**RE: PUCO Case No. 19-1068-EL-BTA  
Amendment to Barnesville-Summerfield 138kV Transmission Line Rebuild  
Project  
Request to Withdrawal Shift 2**

## AMENDMENT CHANGE SUMMARY

### Exhibit 1: Summary of the Changes to the Preferred Route

#### **Exhibit 2: Engineering Adjustment 1**

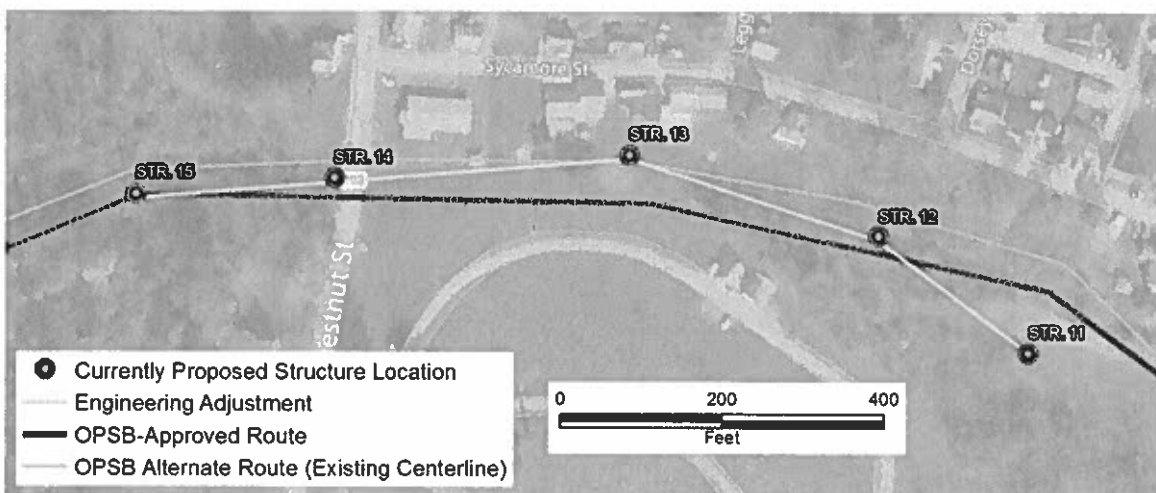
Engineering Adjustment 1 occurs between Structures 11 and 15. The original centerline conflicted with a natural gas pipeline ROW. The newly proposed alignment shifts the OPSB-approved alignment further south at Structure 11 with a maximum adjustment of approximately 75 feet from the OPSB-approved centerline. The remainder of the newly proposed alignment from approximately Structure 12 through Structure 15 shifts the OPSB-approved alignment north. This shift pushes the newly proposed alignment closer to the residences along Sycamore Street; however, no buildings are mapped within the 100-foot ROW. No additional environmental (including tree clearing) or landowner impacts are expected due to Engineering Adjustment 1.

**Exhibit 3: Engineering Adjustment 2**

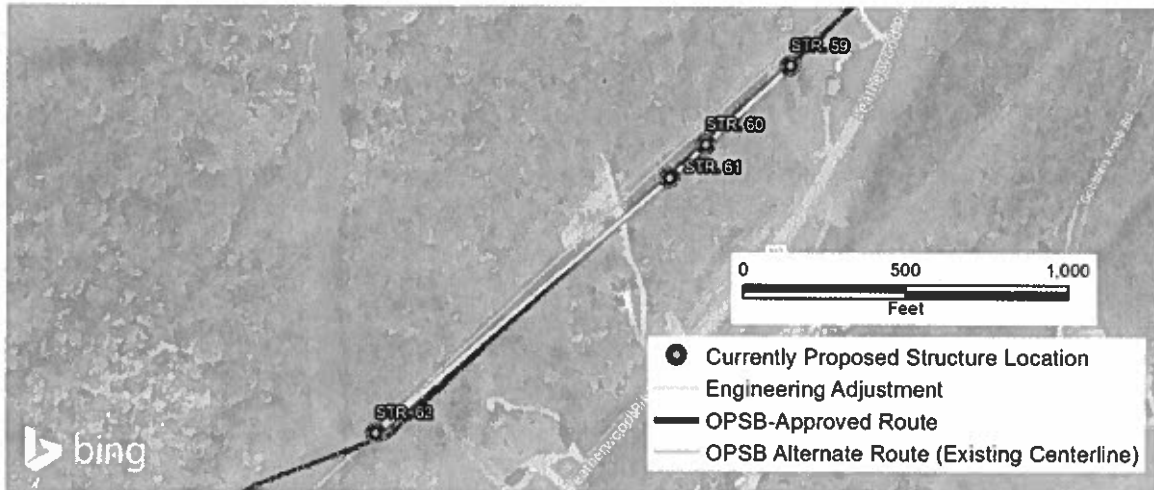
Engineering Adjustment 2 occurs between Structures 59 and 62. Pole locations were adjusted slightly based on detailed survey information and to correspond with more significant changes to the north and south. The maximum adjustment from the OPSB-approved centerline is 19 feet at Structure 62. The amended route results in approximately 4.1 acres of tree clearing within the proposed 100-foot ROW. This is slightly more than the 4.0 acres of tree clearing required for the OPSB-approved route. No additional environmental or landowner impacts are expected due to Engineering Adjustment 2.

**Exhibit 4: Engineering Adjustment 3**

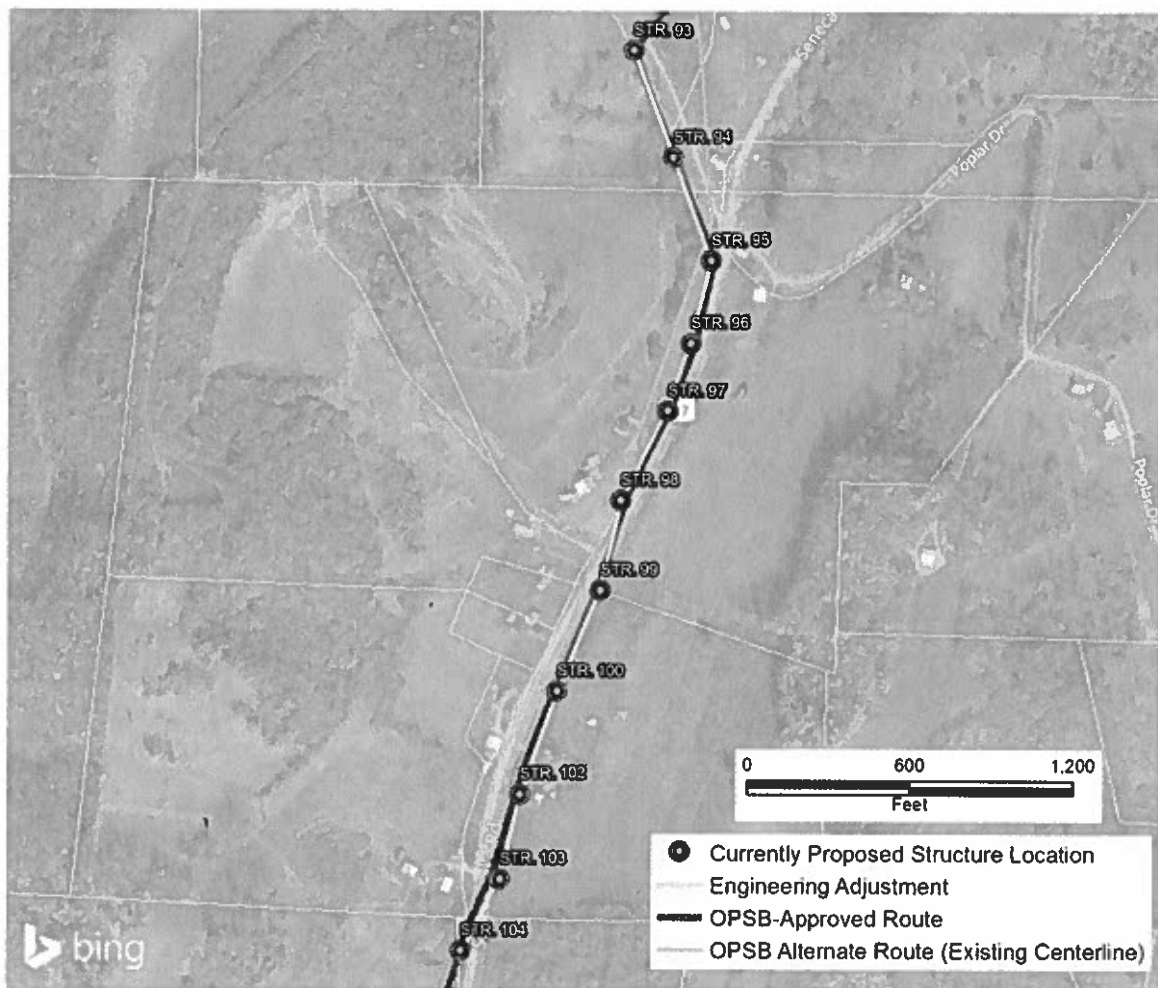
Engineering Adjustment 3 occurs between Structures 93 and 104. The centerline was adjusted to improve the clearance to the nearby distribution line and due to the underground utilities within the area. The maximum adjustment from the OPSB-approved centerline is 38 feet at Structure 103. This adjustment has been constructed. No additional environmental (including tree clearing) or landowner impacts resulted due to Engineering Adjustment 3.

**Exhibit 5: Engineering Adjustment 4**

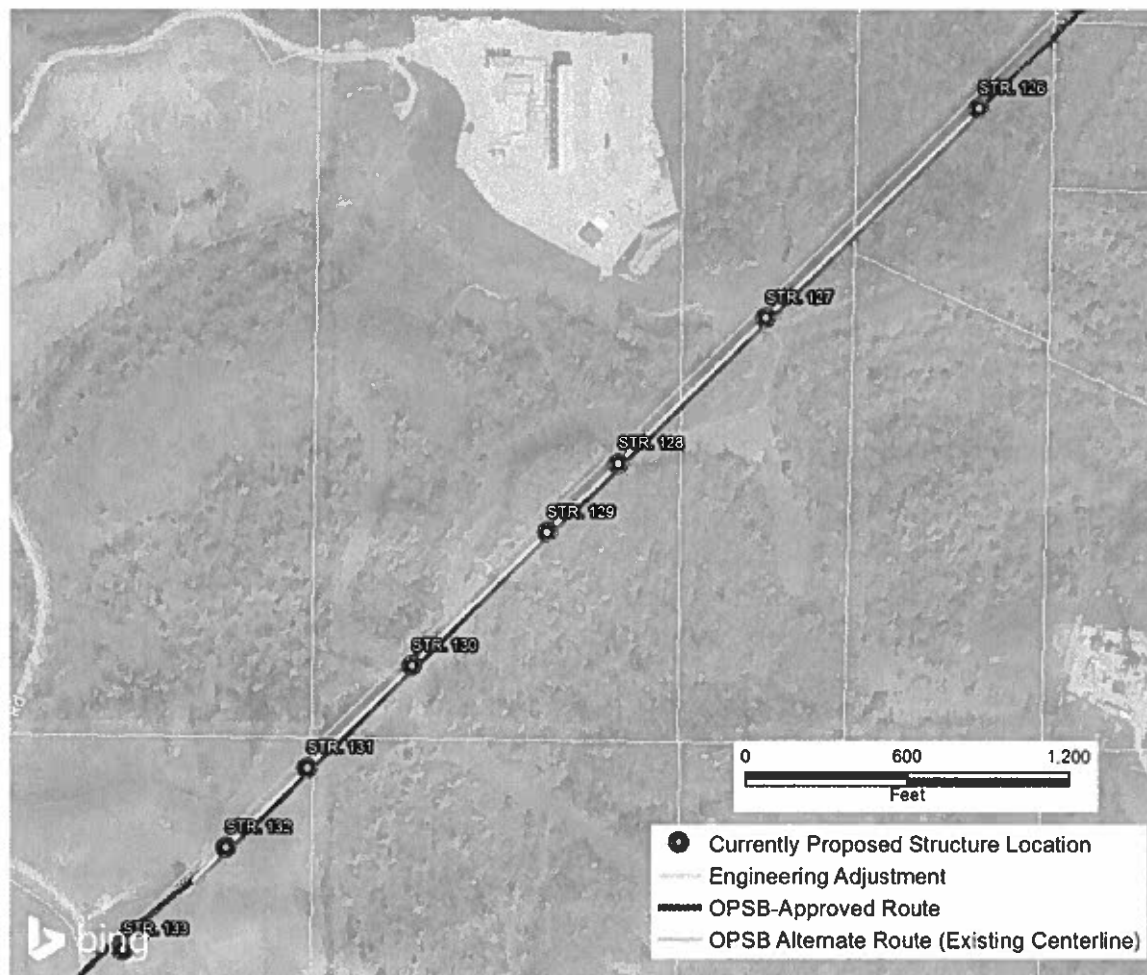
Engineering Adjustment 4 occurs between Structures 126 and 132. These pole locations shifted between one and 11 feet as a result of detailed survey information and minor engineering adjustments. This change reduces tree clearing from approximately 5.5 acres to 4.8 acres. This adjustment has been constructed. No additional environmental (including tree clearing) or landowner impacts resulted due to Engineering Adjustment 4.

**Exhibit 6: Engineering Adjustment 5**

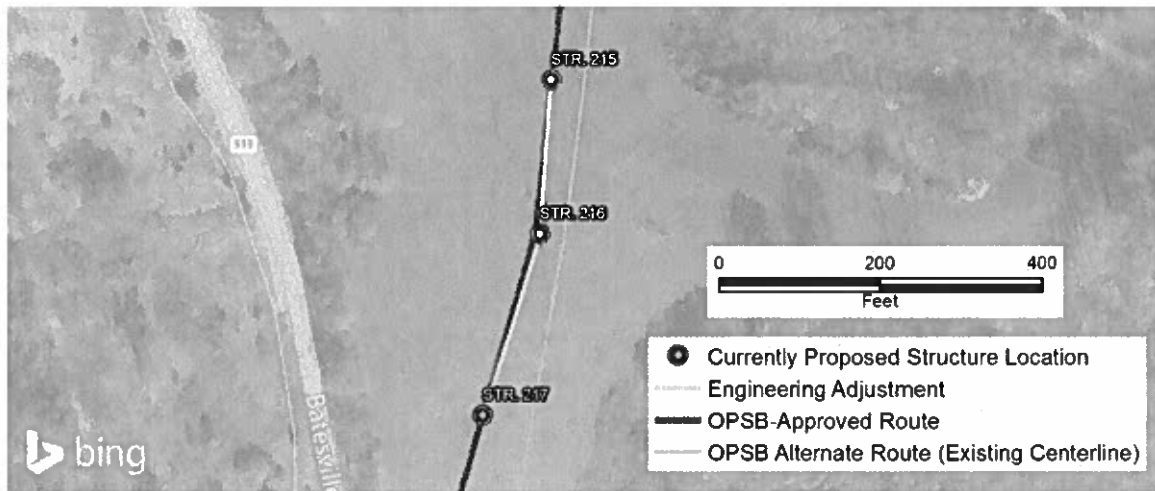
Engineering Adjustment 5 occurs between Structures 215 and 217. The centerline was shifted to avoid an existing well head near structure 216. The well head was discovered within this area after the time of application submittal. Structure 216 was adjusted eight feet from the OPSB-approved centerline. This adjustment has been constructed. No additional environmental (including tree clearing) or landowner impacts resulted due to Engineering Adjustment 5.

**Exhibit 7: Engineering Adjustment 6**

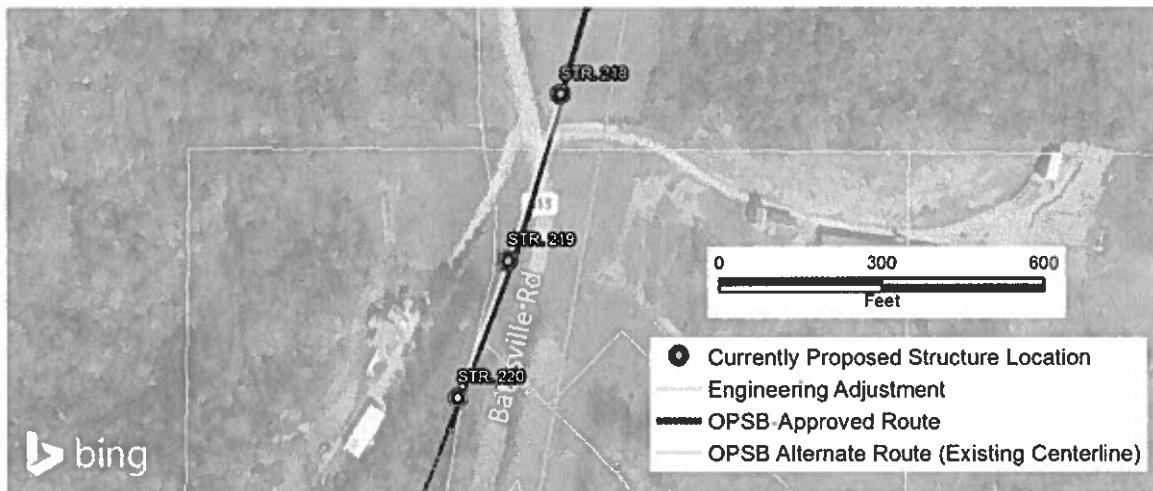
Engineering Adjustment 6 occurs between Structures 218 and 220. The centerline was adjusted to avoid a natural gas line near structure 219. The maximum adjustment from the OPSB-approved centerline is 10 feet at Structure 219. This adjustment has been constructed. No additional environmental (including tree clearing) or landowner impacts resulted due to Engineering Adjustment 6.

**Exhibit 8: Engineering Adjustment 7**

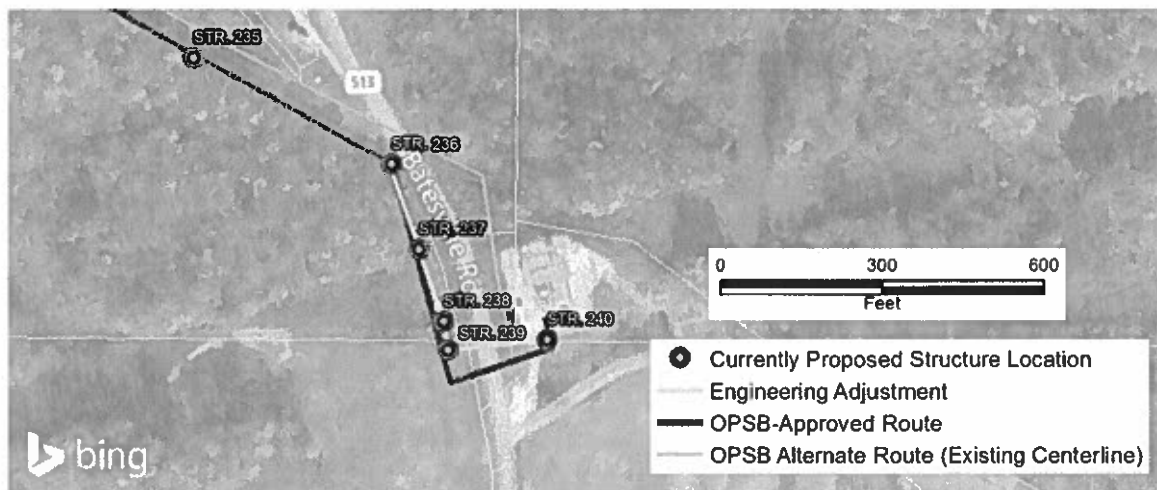
Engineering Adjustment 7 occurs between Structures 236 and 240. The centerline was adjusted to improve clearances to the existing power lines within the area. The maximum adjustment from the OPSB-approved centerline is 17 feet at Structure 238. This adjustment has been constructed. No additional environmental (including tree clearing) or landowner impacts resulted due to Engineering Adjustment 7.

**Exhibit 9: Shift 1**

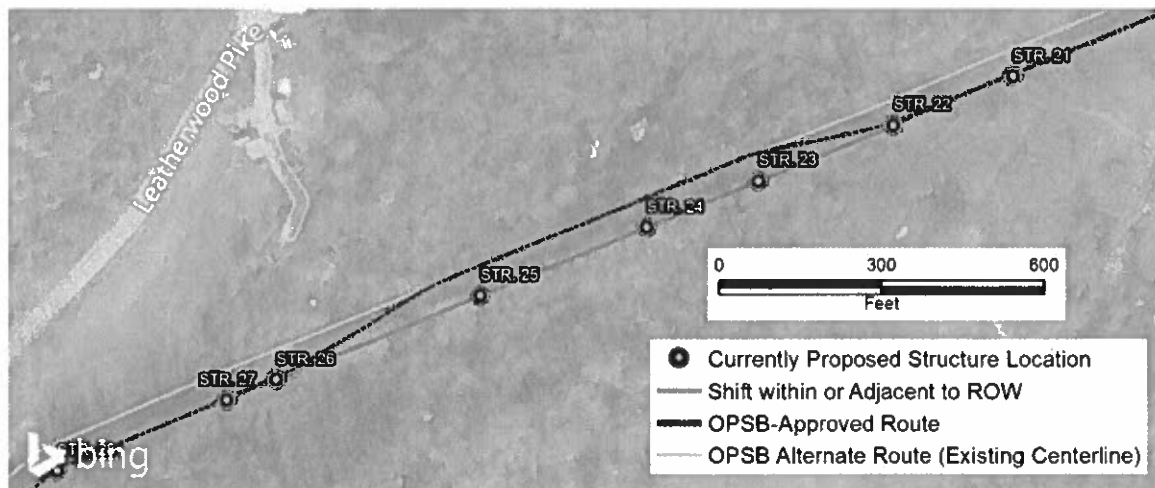
Shift 1 moves the route to an offset position from the existing line consistent with adjacent sections of the centerline between Structures 22 and 26. At the time of submission of the original application, the property owner within this area had suggested that AEP Ohio Transco rebuild on existing centerline. Since then, a new easement has been secured through coordination with the property owner that will allow for construction clear of the existing centerline. By building offset from the existing centerline, AEP Ohio Transco is able to improve safety during construction by constructing clear of the existing line. Shift 1 would potentially result in approximately 0.9 acre of additional tree clearing on the south side of the amended route, which lies outside of the existing centerline ROW. No additional environmental or landowner impacts are expected due to Shift 1.

**Exhibit 11: Shift 3**

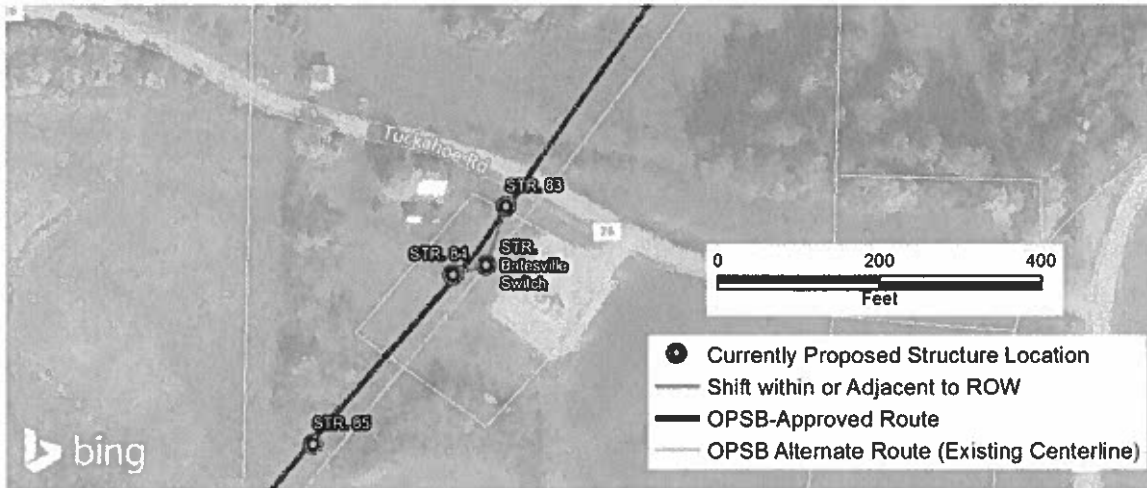
Shift 3 adjusts the alignment between Structures 83 and 84 to attach to the existing Batesville Switch. This shift within the existing ROW did not add any additional parcels or landowners. No new environmental impacts are anticipated. No additional pole will be installed as the centerline shift is to attach to the existing Batesville Switch pole. This adjustment has been constructed. No additional environmental (including tree clearing) or landowner impacts resulted due to Shift 3.

**Exhibit 12: Shift 4**

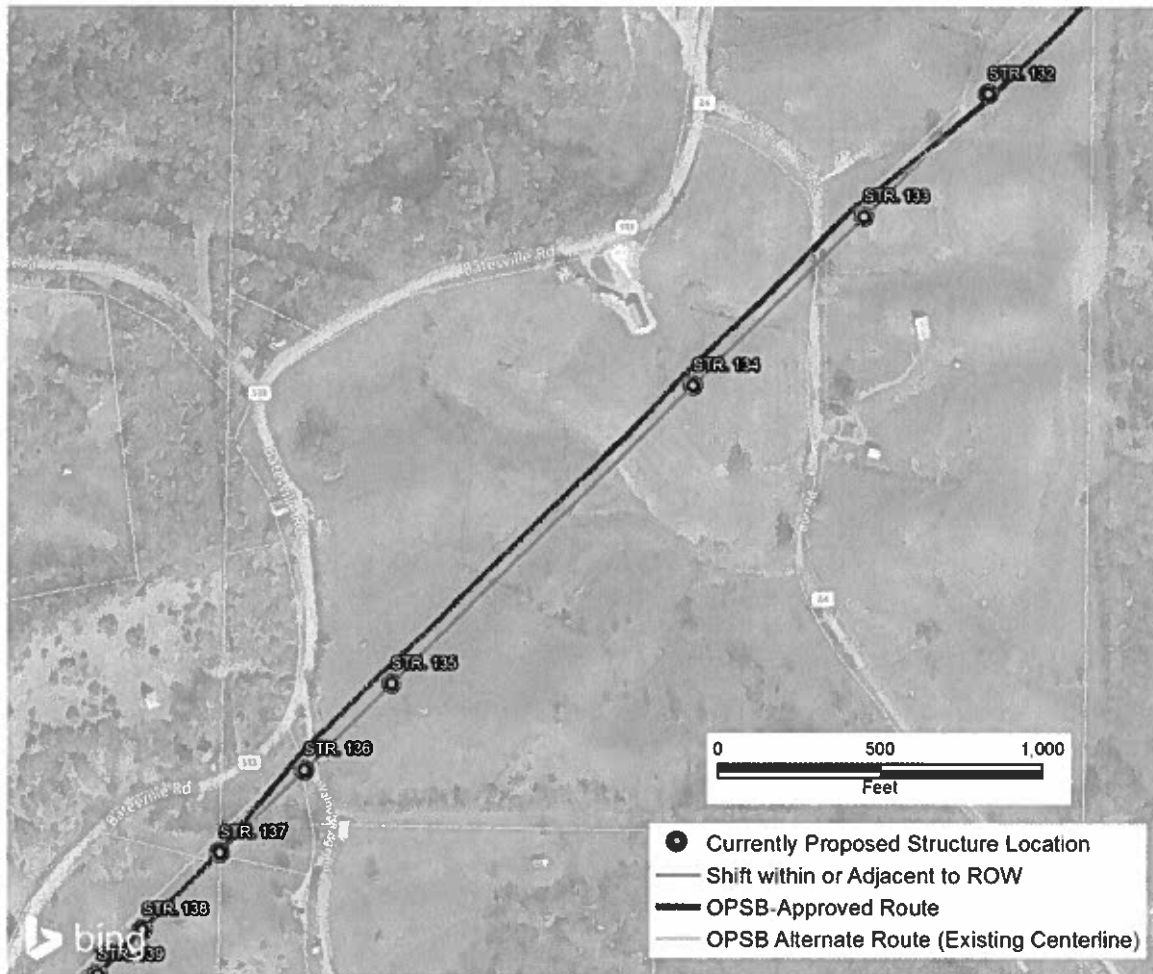
Shift 4 moves the route from the existing centerline to offset between Structures 132 and 137. At the time of submission of the original application, the property owner within this area had suggested that AEP Ohio Transco rebuild on existing centerline. Since then, a new easement has been secured through coordination with the property owner that will allow construction clear of the existing centerline. By building offset from the existing centerline, AEP Ohio Transco is able to improve safety during construction. This adjustment has been constructed. No additional environmental (including tree clearing) or landowner impacts resulted due to Shift 4.

**Exhibit 13: Shift 5**

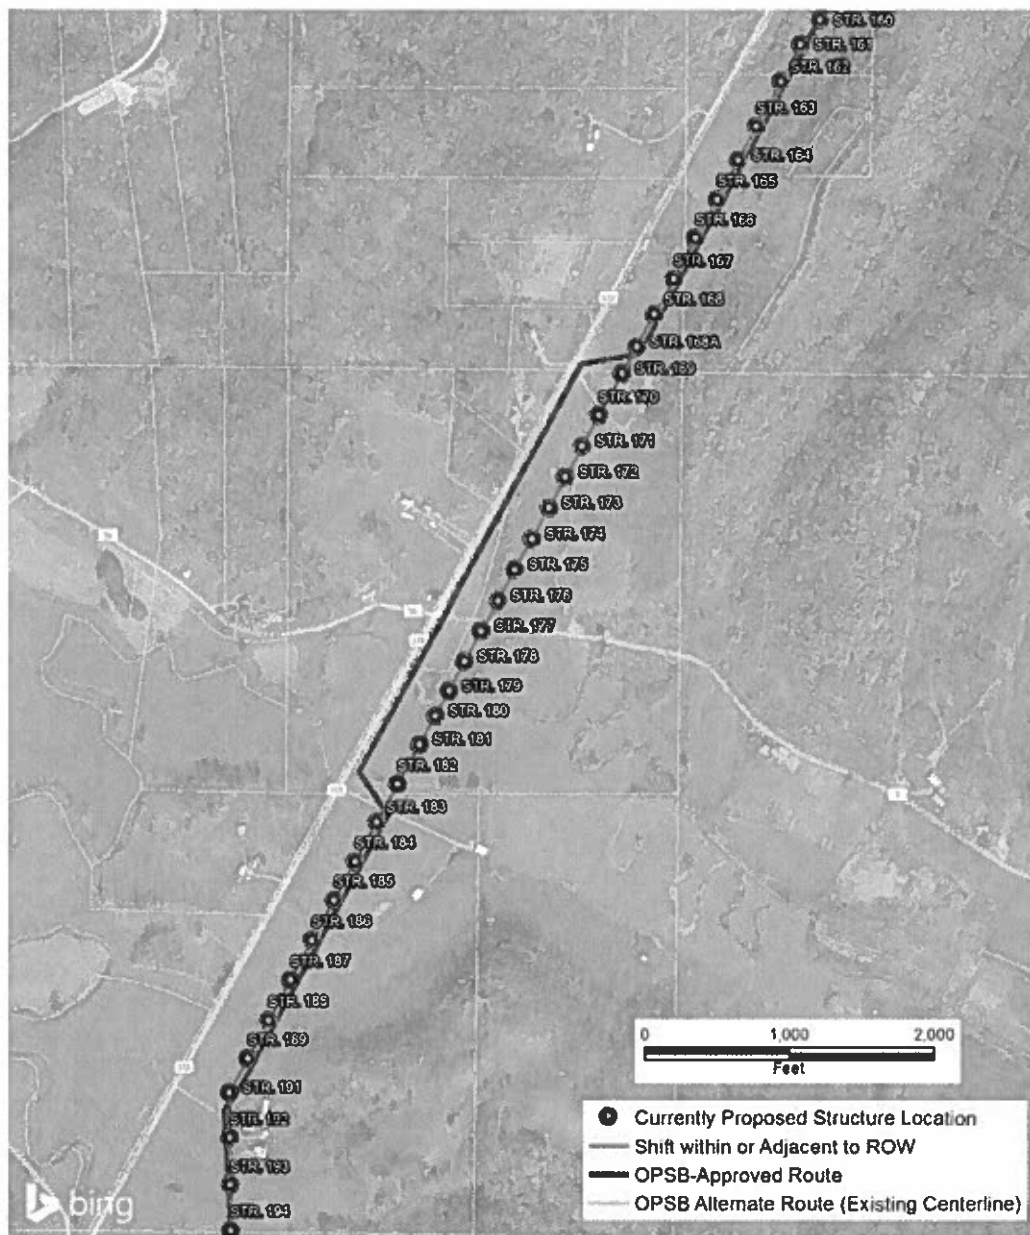
Shift 5 moves the route to the existing centerline between Structures 160 and 194. This shift within the existing ROW did not add any additional parcels or landowners. The shift results in the centerline crossing approximately 200 additional feet of Ohio Rapid Assessment Method (ORAM) Category 1 emergent wetland. However, no disturbance is proposed within the wetland. The centerline was shifted due to the property owner's request. Due to the ability reduce the number of turns and move the proposed centerline further from adjacent residential properties, AEP Ohio Transco decided to shift back to the existing centerline. No additional environmental (including tree clearing) or landowner impacts are expected due to Shift 5.
